## HOLDOVER

### **SHIPMAN PLACE SUBDIVISION**

APPLICATION NUMBER Holdover DATE June 3, 2004

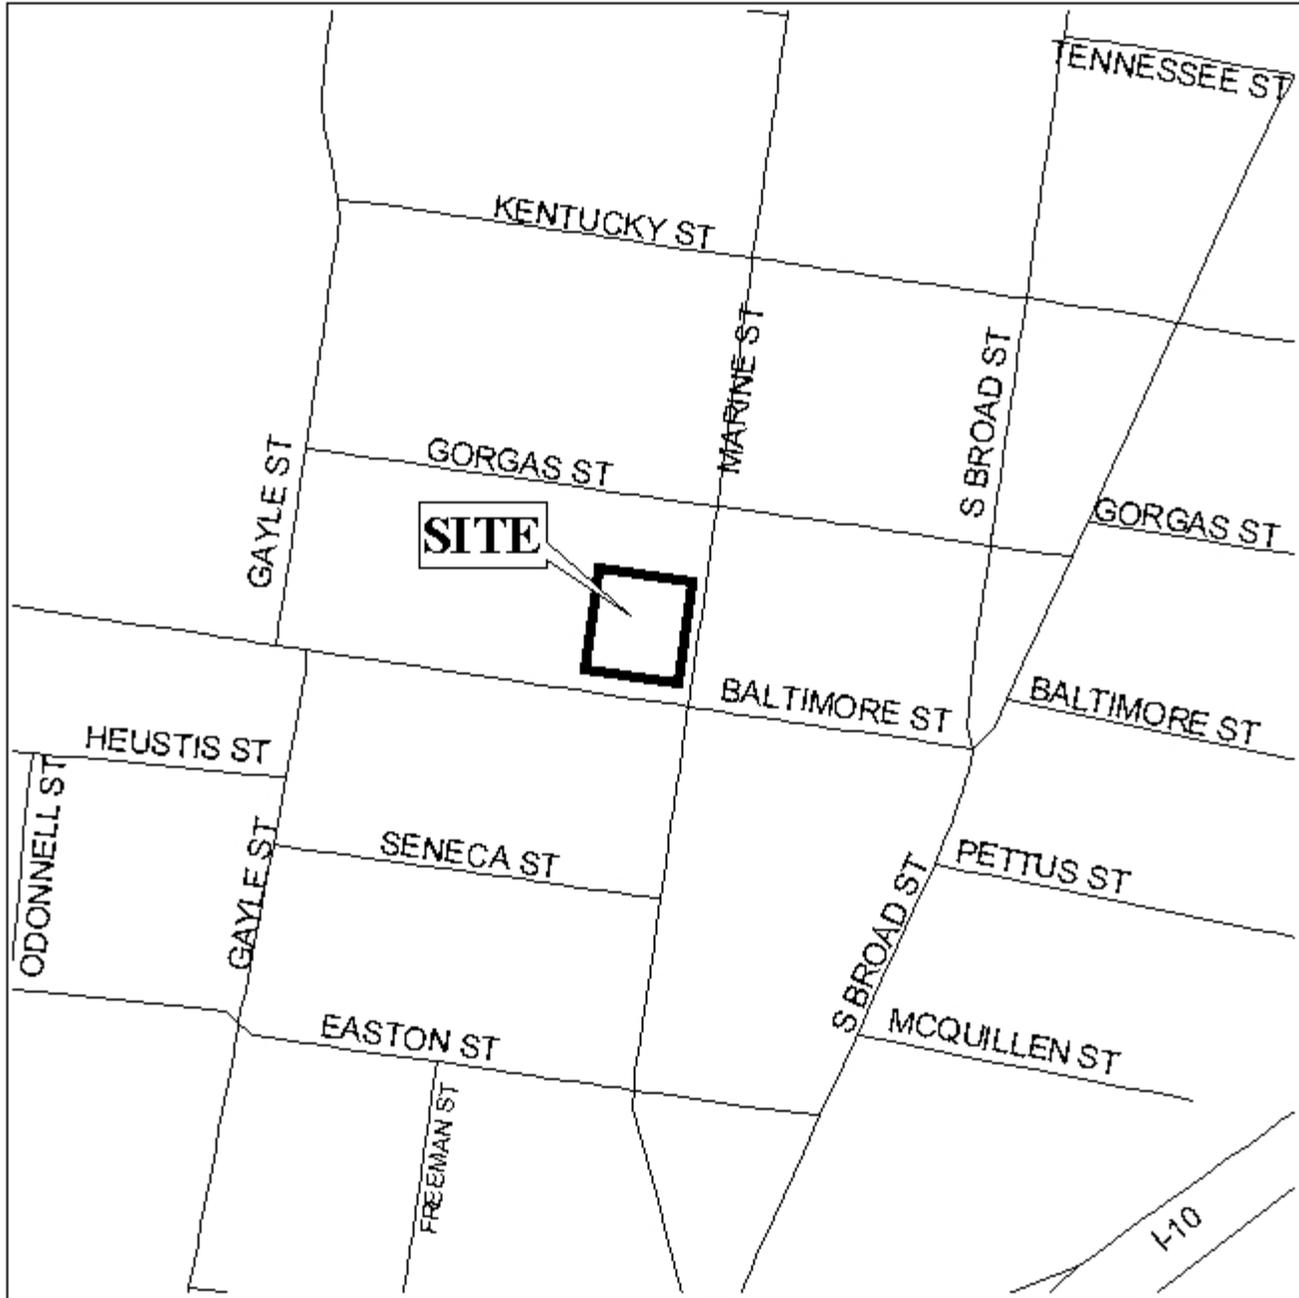
The 25-foot minimum building setback lines are not shown but would be required on the final plat.

*This application was heldover from the Commission's May 20<sup>th</sup> meeting to allow the applicant to submit documentation to establish the balance of the property as a legal lot of record prior to 1952, or to include the balance of the property in the subdivision. The applicant has since submitted documentation illustrating that the corner parcel is a nonconforming lot of record established prior to 1952 as well as a revised plat which includes the balance of the property to the West increasing the subdivision to three lots.*

*Lot 3 would exceed the maximum width to depth ratio, therefore a waiver of Section V.D.3. of the Subdivision Regulations would be required.*

*With a waiver of Section V.D.3. (width to depth), the plat will meet the minimum requirements of the Subdivision Regulations and is recommended for Tentative Approval as a three-lot subdivision subject to the following condition: 1) the placement of the 25-foot minimum setback line on the final plat.*
